Title: NRW response – Gnoll Park
Date: 05/02/2024
Version: P2

This note outlines the design response to the comments raised by Natural Resources Wales during their consultation on the 6th September 2023 (NRW ref CAS-236747-Q9H2).

GNOLL PARK
FISH POND

BWRIAD/PROPOSAL: DEMOLITION OF EXISTING VISITORS CENTRE AND CONSTRUCTION OF NEW 2-STOREY VISITOR CENTRE INCLUDING NEW BALUSTRADES, SPRINKLER TANK, EXTERNAL LIGHTING OF PEDESTRIAN ROUTES FROM EXISTING CAR PARK AND ASSOCIATED LANDSCAPING AND DRAINAGE WORKS.

File No.		Financial Code No.			
Drawn	BJD	Checked	PGG	Approved	MPT
Date	MAY 10	Date	MAY 10	Date	MAY 10
Scales	1 : 1250				
Drawing No.	GNOLL/FISHPOND/GEN/1

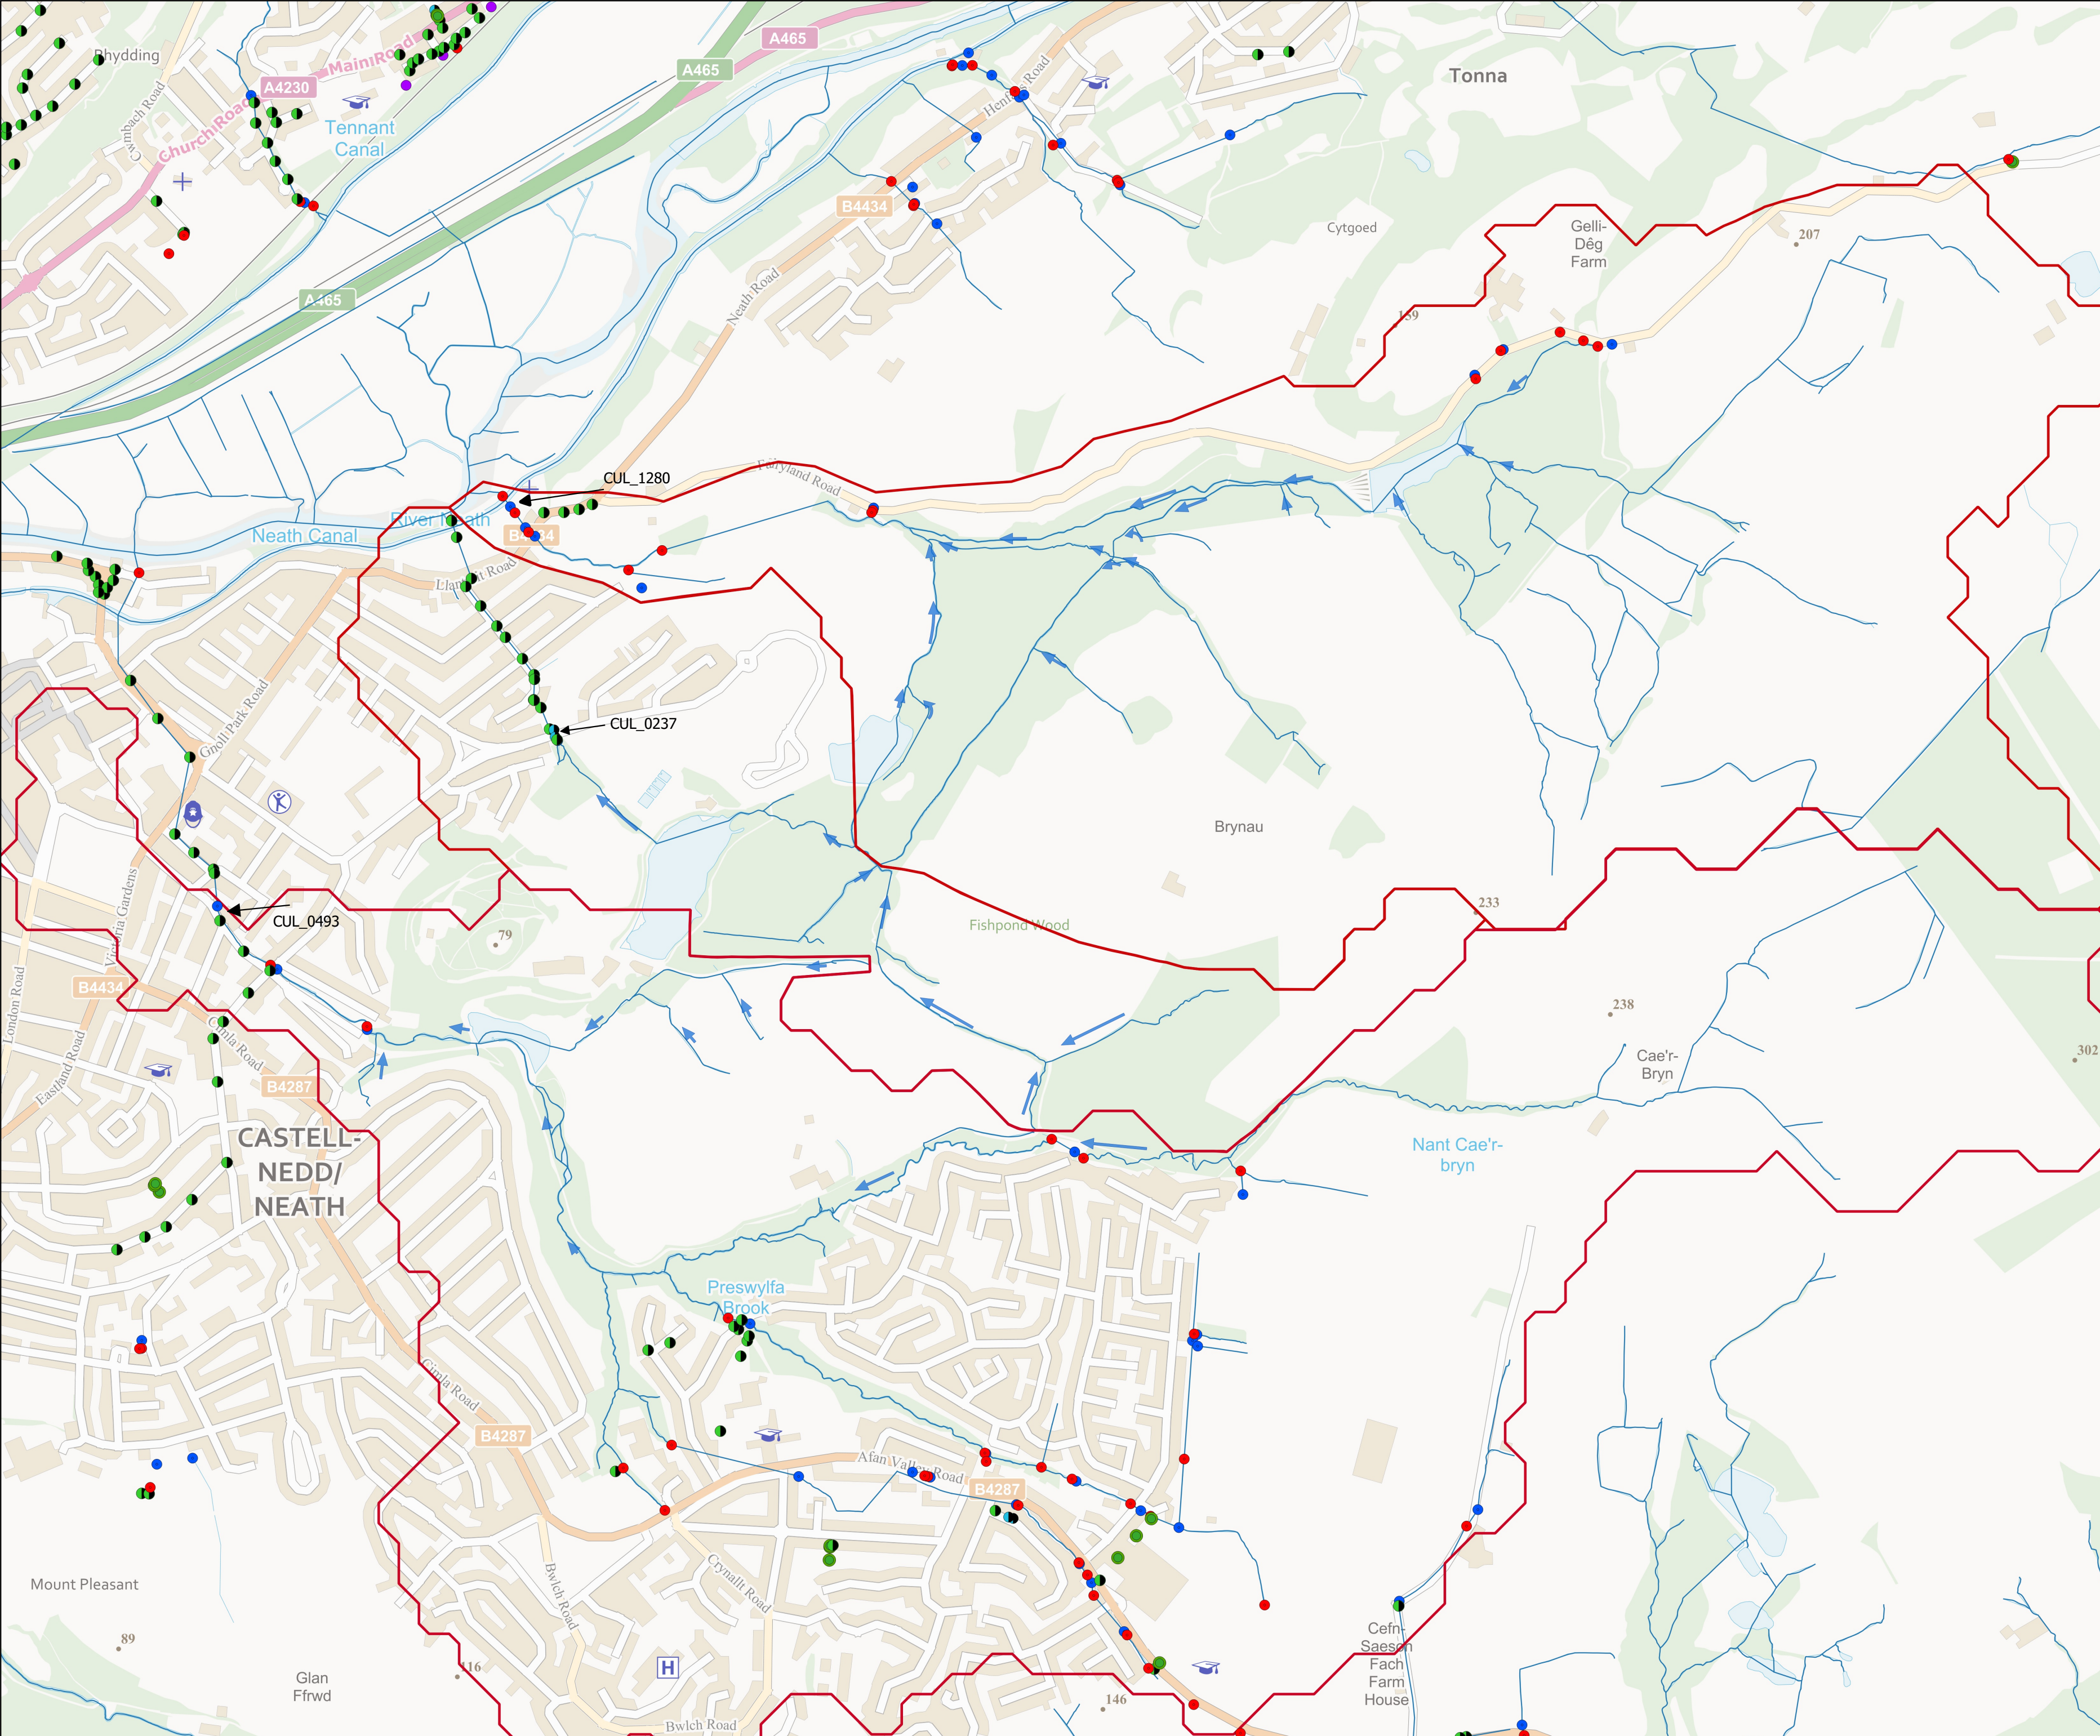
“We must highlight that the streams are ephemeral and dry up during periods of no rainfall, which could potentially lead to insufficient dilution of the effluent for large periods of the year. The two ponds on site currently suffer from algal blooms and low dissolved oxygen level and therefore discharging treated sewage effluent into the ponds could exacerbate the situation.”

The point raised regarding insufficient dilution remained and was raised as a risk by NRW on their review of the new proposal resulting in a request for further information on the management of the ponds water levels and flows to alleviate their concerns. Edward Davies attended site on the 15th January 2024 and agreed that the park team were able to demonstrate sufficient control of the upstream ponds water level to provide suitable dilution throughout the year. The methods of controlling the water levels are described within section III.

The pond water level is managed through a series of controls which locations and means have been captured within Appendix A – Water Management Controls Plan.

“Each day, a site ranger will check all of the watercourses and their associated inlets and outlets. If the rangers discover that the water levels in Fish pond are lower than required then they will divert flows from other sources into the pond via 2 sluice gates. One sluice gate is located on the road to Preswelfa dingle (Location B within Appendix A) and can be opened and closed when needed. This allows water to flow down the site and into the cascades, which feed directly into the Fish pond. The second sluice gate is located in front of the halfway house. This controls the water that runs down from the North, this device can control the diversion of water into the fish pond or to the back of the Guinea pond (Location B within Appendix A) which subsequently discharges into the Fish pond at the outlet next to the Visitors Centre. In order to control the water levels within fishpond, there are 2 stop logs that can be used to alter water levels as needed throughout the year. In addition, there are a series of additional diversion points and sluice gates across the site that can be used to control the water going in and out of the pond”

The above process has been discussed with Edward Davies during the site meeting/walkover, it was agreed that from an ecological perspective that the forementioned methods are sufficient to alleviate their concerns with the dilution of the treated foul water as a constant flow throughout the year can be achieved.
